From: [REDACTED] (Chair) [REDACTED] >
To: "lburnett"<[REDACTED]>, "sdperkes"<[REDACTED]>
Cc: "St Athan Community Clerk"<[REDACTED]>
Date: Mon, 29 Dec 2025 14:11:12 +0000
Subject: Clive Road Development
===== Forwarded message =====

Re: Local Development Plan (LDP) – Clive Road Field Allocation

Submission to the Vale of Glamorgan Scrutiny Committee from the Thaw Valley Group

Table 3.1 Project Summary									
Date:	10 th November 2022								
Document reference:	22106 d1								
Prepared by:	Thaw Valley Group								
On behalf of:									
Authorisation sheet									
Project:	Bryn Melin Development, St Athan Road, Cowbridge								
Report title:	Road Safety Audit Stage 1								
Prepared by:									
Name:									
Signed:									
Organisation:	Thaw Valley Group								
Date:	10 th November 2022								
I APPROVE THE RSA BRIEF AND INSTRUCT THE RSA TO TAKE PLACE ON BEHALF OF THE OVERSEEING ORGANISATION:									
Name:									
Signed:									
Organisation:									
Date:									
Table 3.2 General Details									
General Details									
Highway scheme name and road name:	Bryn Melin Development, St Athan Road, Cowbridge								
Type of scheme:	Stage 1 Road Safety Audit of the

Fig 1 . Original site of 4.3 hectares for 130 houses

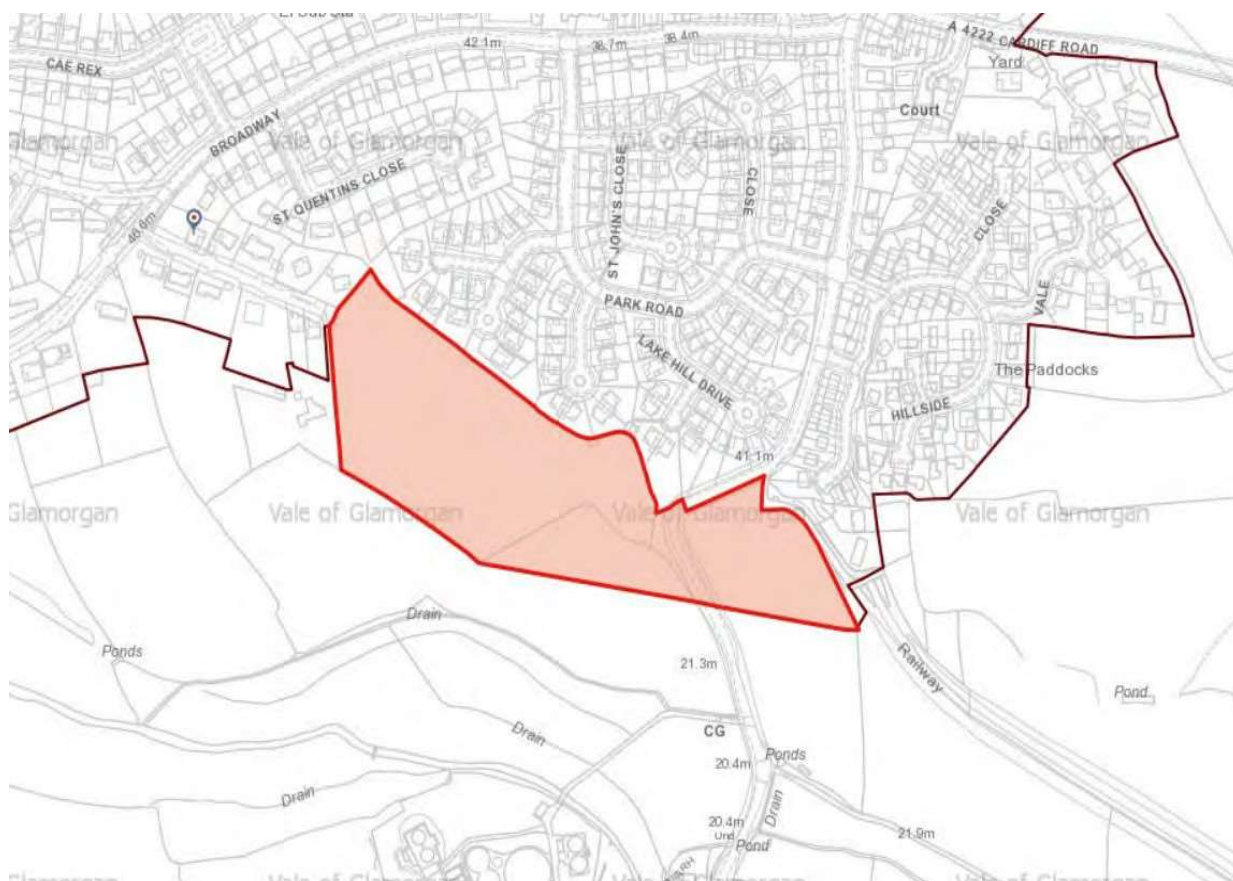
It is clear from the drawings above that the sites are different. The new site is supposed to be 3.8 Ha but additional land has been added to the original proposal whilst some land has been deleted. All of the land to the east of the St Athan Road has been removed and some additional land to the south of the site has been added for an attenuation basin together with a small triangle of land (existing green space on Brookfield Park estate not owned by the promotor/ developer) to the North. The resulting size of the new site is approximately 4.2 Ha. According to the guidelines this should have a density of 30 houses per hectare. i.e 126 houses. Only 105 houses have been proposed.

New/existing road interface

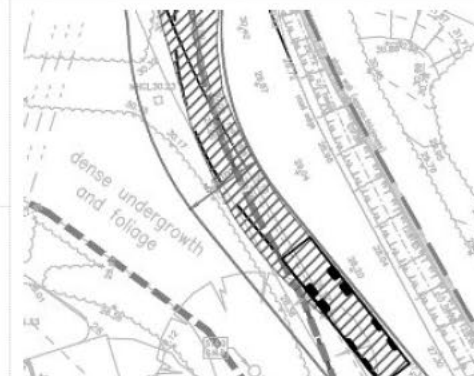
2.1.4 Summary Swept-path analysis of a large (refuse) vehicle shows the body of the vehicle over-sweeping the centreline of St Athan Road, at a point where the realigned carriageway reverts to the existing alignment and encroaches into the opposing lane. This could lead to head on or side-swipe type collisions, or for drivers to take avoiding action.

It is noted from the plans provided that the body of the vehicle over-sweeping the centreline of St Athan Road, at a point where the realigned carriageway reverts to the existing alignment and encroaches into the opposing lane. This increases the potential for head-on or side-swipe type collisions, or for drivers to take avoiding action, increasing the potential for vehicles to mount the pavement (which is not shown on the swept-path diagram, but included on the site layout plan) and conflict with pedestrians.

Layout

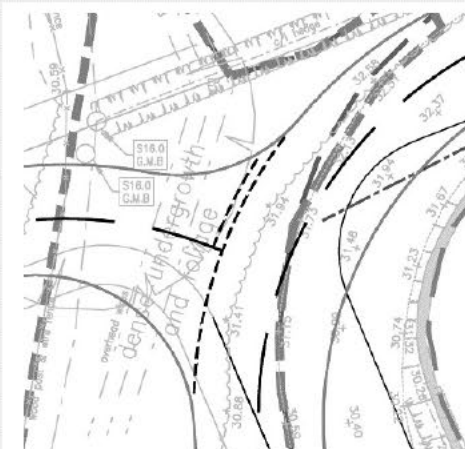
2.2.1 Summary It is unclear from the plans provided whether there is sufficient space for a large vehicle, travelling northbound along St Athan Road, to pass another vehicle waiting to turn right into the proposed development. Insufficient width could lead to side-swipe type collisions.

Location Realigned St Athan Road at the proposed junction on to Roman Road

It is recommended that additional swept-path analysis of the range of vehicles using St Athan Road and likely to use the new access is undertaken to determine whether there is sufficient room, and that the junction/access is amended accordingly.

Location Potential access to land to the south and east of St Athan Road

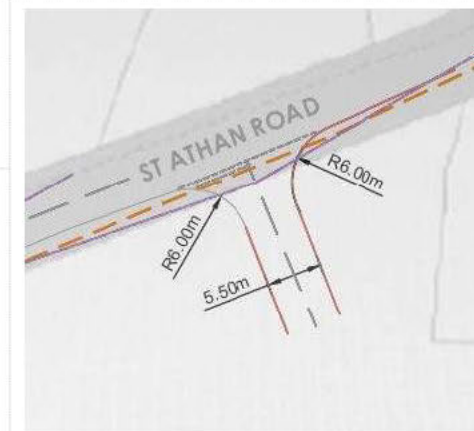
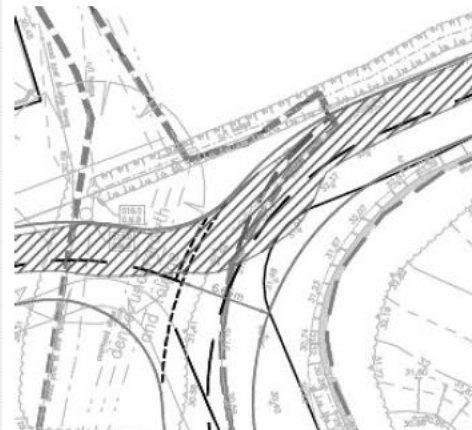
2.2.2 Summary The width of St Athan Road at the potential access measures approximately 4.5m wide, which is insufficient for a large vehicle, travelling southbound along St Athan Road, to pass another vehicle waiting to turn right into the proposed development. Insufficient width could lead to side-swipe type collisions.

It was noted from the site visit that St Athan Road, at the potential access, measures approximately 4.5m wide. This is insufficient for a large vehicle, travelling southbound along St Athan Road, to pass another vehicle waiting to turn right into the proposed development. Insufficient width could lead to side-swipe type collisions.

Location Windmill Lane, on the approach to Broadway.

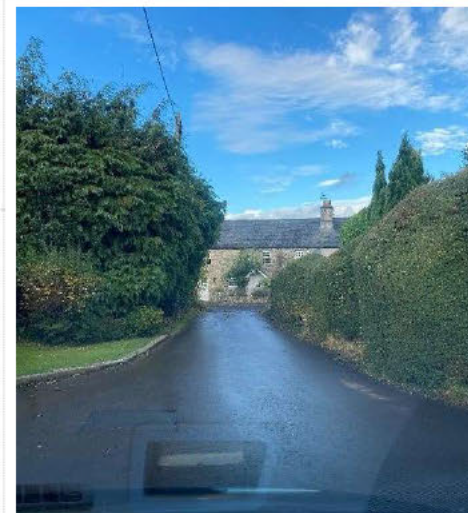
2.3.3 Summary The proposed pedestrian/cycle link to the site from Windmill Lane is of substandard width, particularly on the approach to Broadway, where there is insufficient width for a car to pass a pedestrian, particularly a pedestrian with a pushchair or those using a wheelchair, increasing the potential for pedestrians to be hit by passing vehicles.

It is noted from the plans provided that it is proposed to provide a pedestrian and cycle access to the site from Windmill Lane, which is a shared-surface road serving approximately 12 dwellings. However, it was noted from the site visit that the width of Windmill Lane reduces on the approach to Broadway and there is insufficient width for a car to pass a pedestrian (particularly a pedestrian with a pushchair or those using a wheelchair) or a cyclist. This increases the potential for pedestrians to be hit by passing vehicles. This is exacerbated by the limited visibility from Broadway (w) to Windmill Lane.
